**RE: B&D Industries
9720 Bell Ave SE
Temporary C.O. - Accepted
Engineer's Certification Date: 07/10/20
Engineer's Stamp Date: 10/4/19
Hydrology File: L20D071**

DRAINAGE AND TRANSPORTATION INFORMATION SHEET (REV 6/2018)

ENGINEER'S SEAL	Title: B&D INDUSTRIES, INC. 9720 BELL AVE. SE	DRAWN BY DATE
RICHARD H. DOURTE REGISTERED PROFESSIONAL ENGINEER NEW MEXICO 10854	GRADING AND DRAINAGE PLAN	SHEET # 1 OF 1
10-04-19	RHD Engineering, LLC 4305 Purple Sage Ave. NW ALBUQUERQUE, NM 87120 (505) 288-1621	JOB #
Richard Dourte P.E. #10854

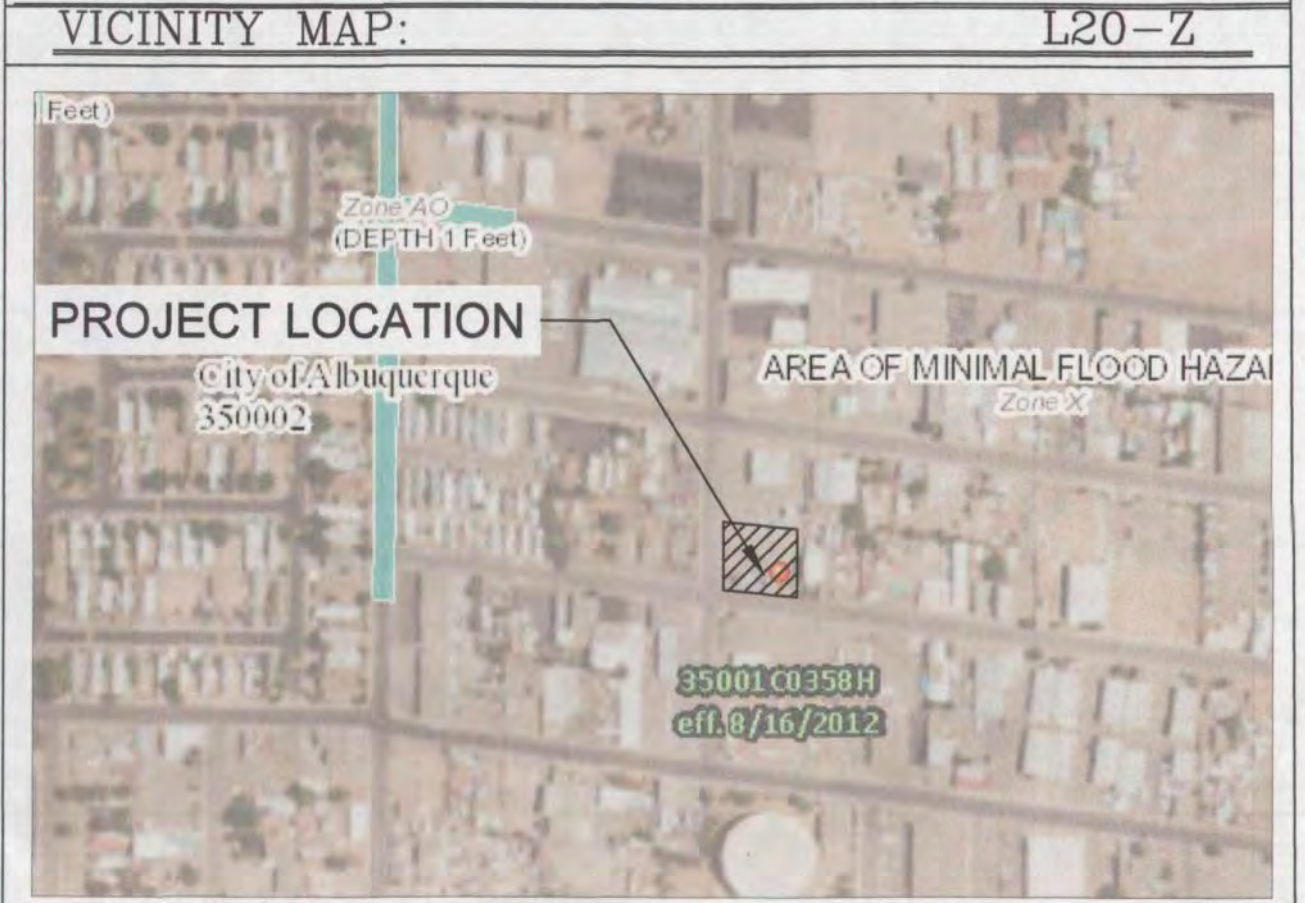
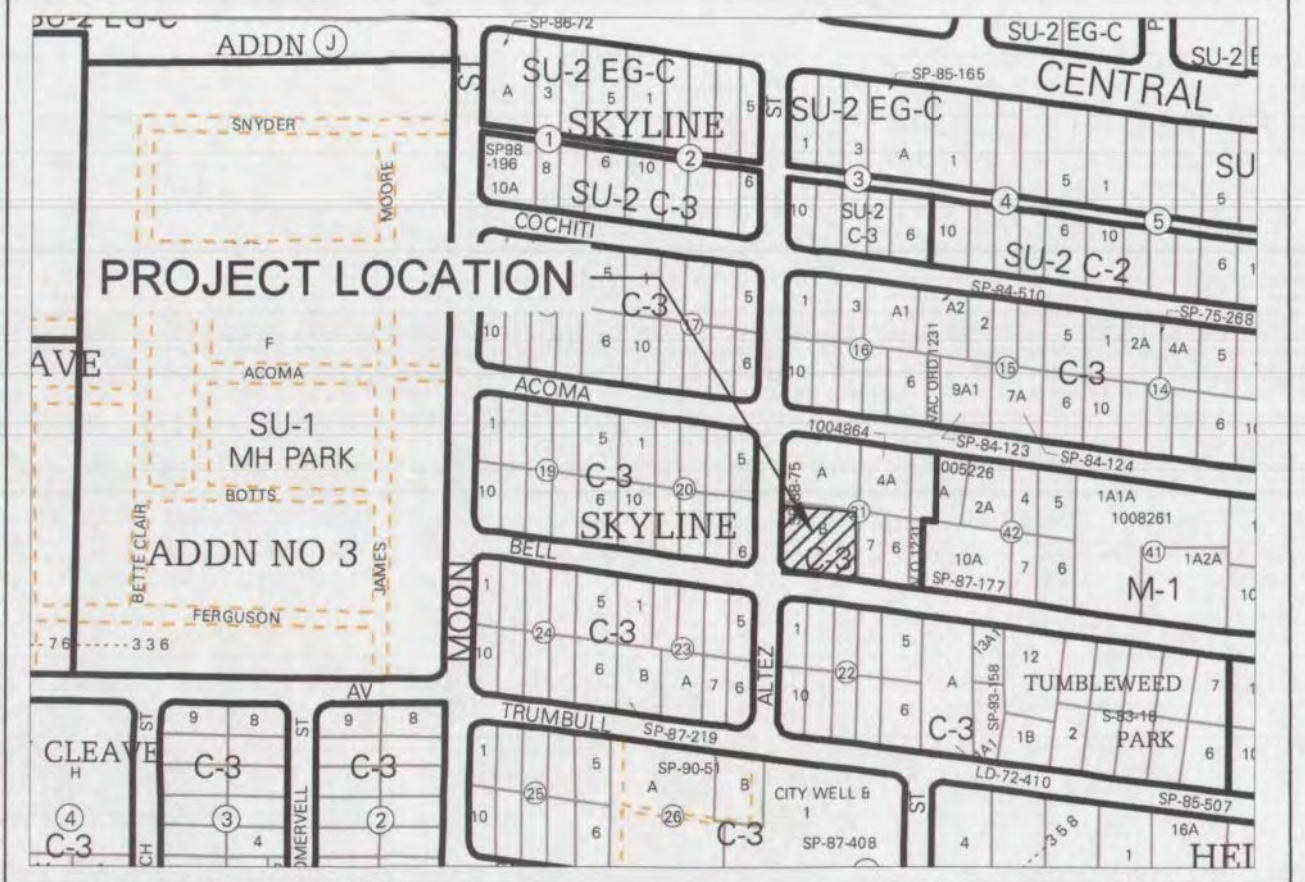
1. The sidewalk culvert must be inspected and approved by Storm Drain Maintenance (Augie Armijo at (505) 857-8607). I have already been in contact with him and I'm waiting for his inspection.
2. There appears to have been parking installed over the stormwater quality pond. This will need to be addressed and the as-built volume needs to be calculated. If the volume is less than what is required, then a payment-in-lieu will need to be paid.
